Improved Technical Specifications

Dresden Station

Volume 2:
Section 3.1 and Section 3.2

ComEd

Figure 3.1.7-2

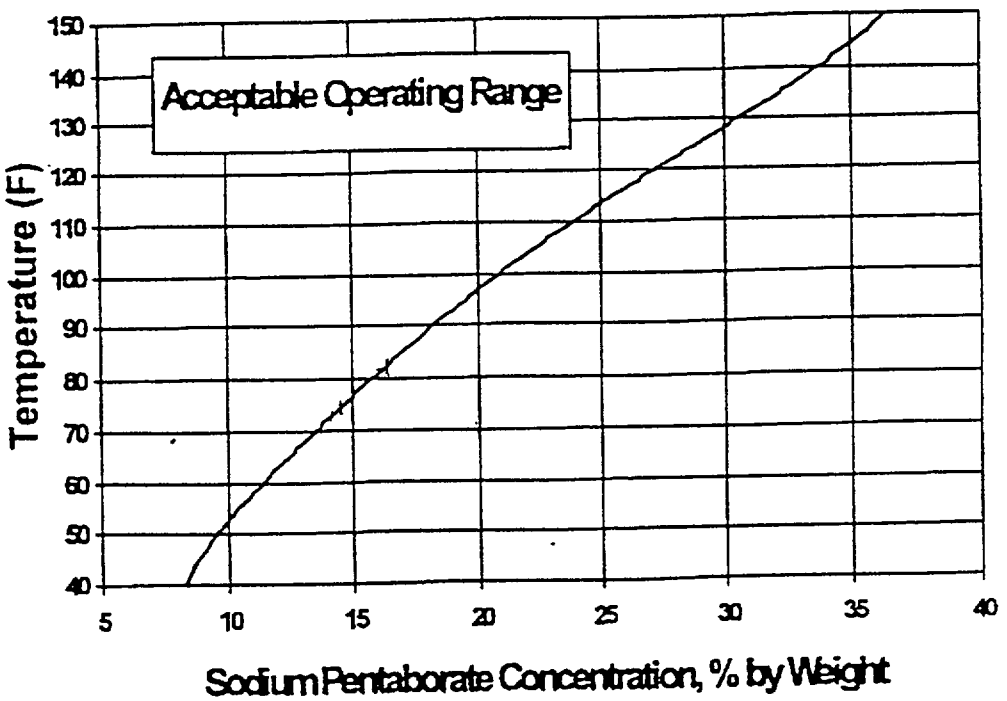
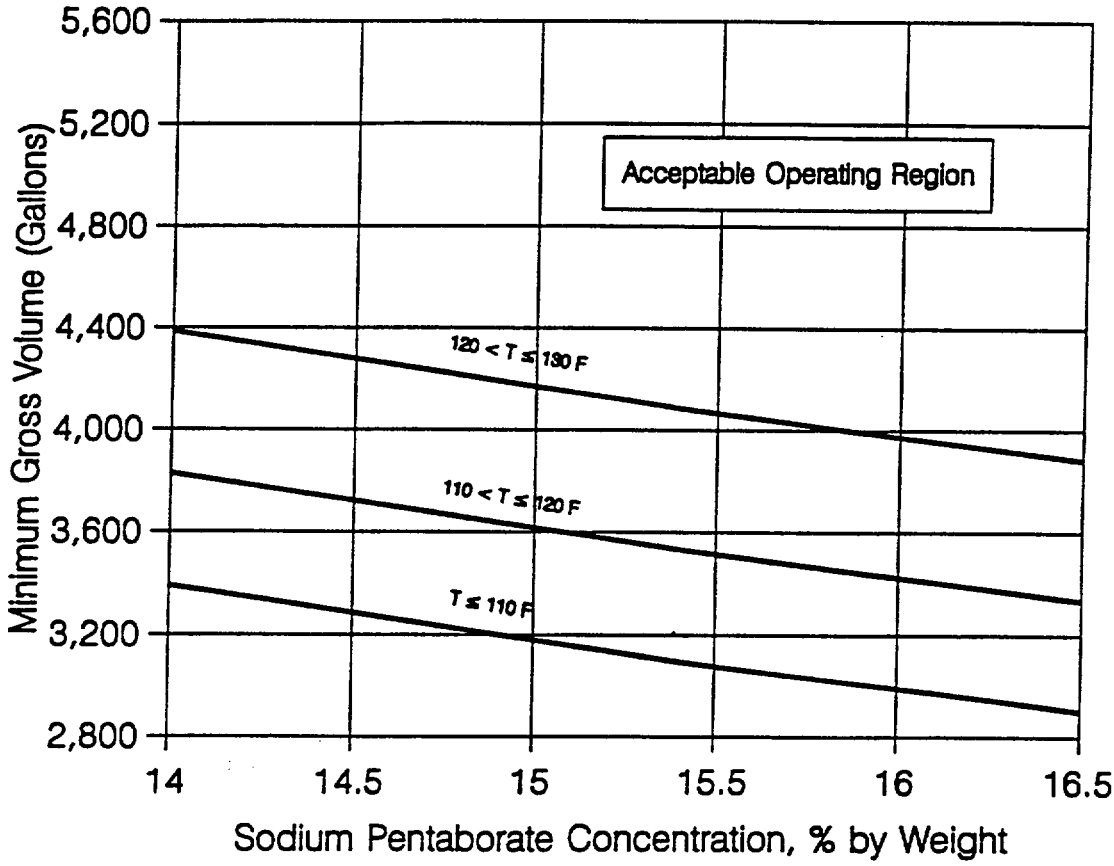
A.3 The details of CTS 4.4.A.2.b, which identify the available boron concentration to be determined to be 14% to 16.5% by weight, are revised in proposed SR 3.1.7.5 to be within the limits of Figure 3.1.7-1. Since the limits identified in the Figure correspond to the same 14% to 16.5% by weight related to the volume requirement, this change is considered a presentation preference consistent with the BWR ISTS, NUREG-1433, Rev. 1. Therefore, this change is administrative.

M.2 (cont'd) Figure 3.1.7-2 (CTS Figure 3.4.A-1). This change is considered more restrictive since an explicit Surveillance will be required whenever the limits of Figure 3.1.7-2 are not met. However, this change is necessary since precipitation of the boron from solution may occur when the temperature requirements are not met.

Insert Figure 3.1.7-1

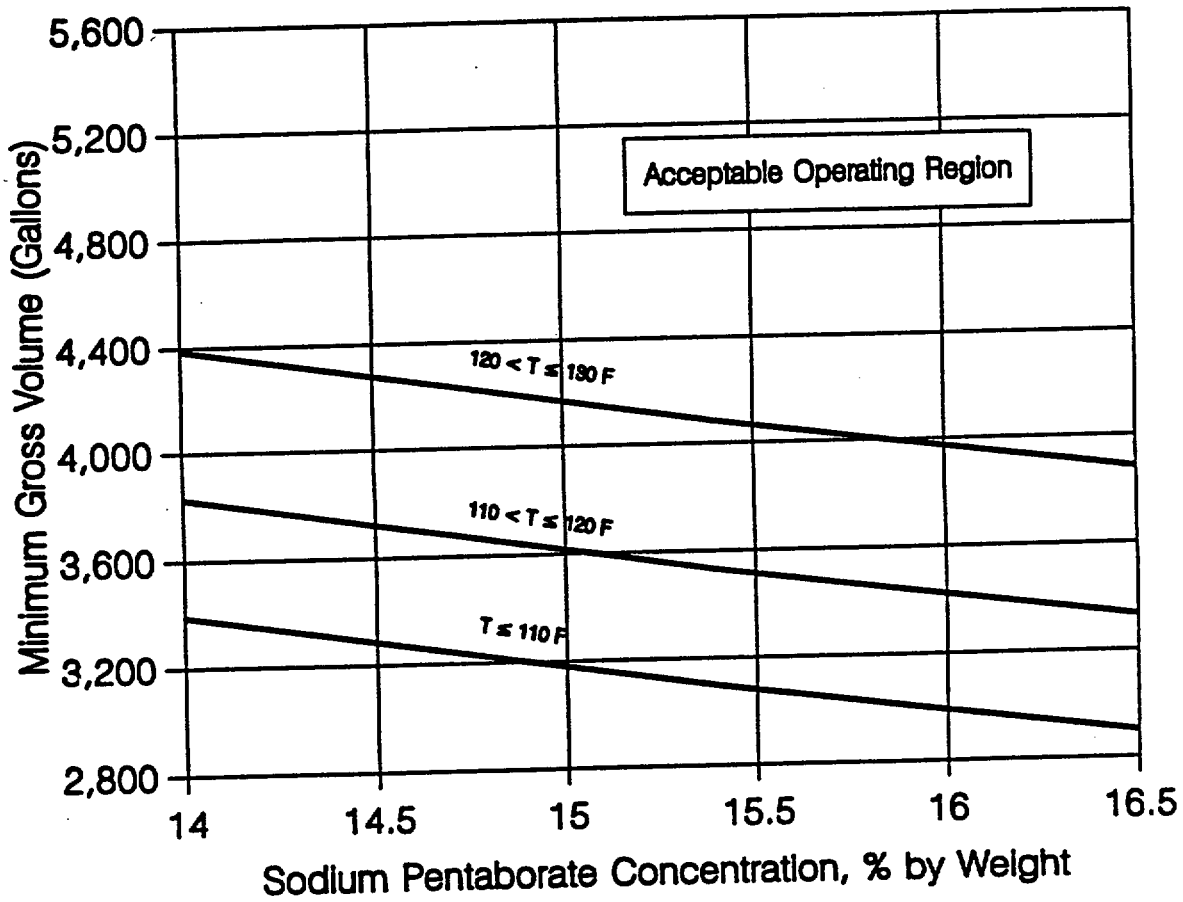
SURVEILLANCE		FREQUENCY
<4.4.A.1.b>	SR 3.1.7.1	Verify available volume of sodium pentaborate solution is within the limits of Figure 3.1.7-1, or ≥ 4530 gallons.	24 hours
<4.4.A.1.a>	SR 3.1.7.2	Verify temperature of sodium pentaborate solution is within the limits of Figure 3.1.7-2.	24 hours
<4.4.A.1.c>	SR 3.1.7.3	Verify temperature of pump suction piping is within the limits of Figure 3.1.7-2. ≥ 83° F	24 hours
<4.4.A.2.a>	SR 3.1.7.4	Verify continuity of explosive charge.	31 days
<4.4.A.2.b> <4.4.A Footnote (a)>	SR 3.1.7.5	Verify the concentration of boron in solution is within the limits of Figure 3.1.7-1. sodium pentaborate 3	31 days AND Once within 24 hours after water or boron is added to solution AND Once within 24 hours after solution temperature is restored within the limits of Figure 3.1.7-2
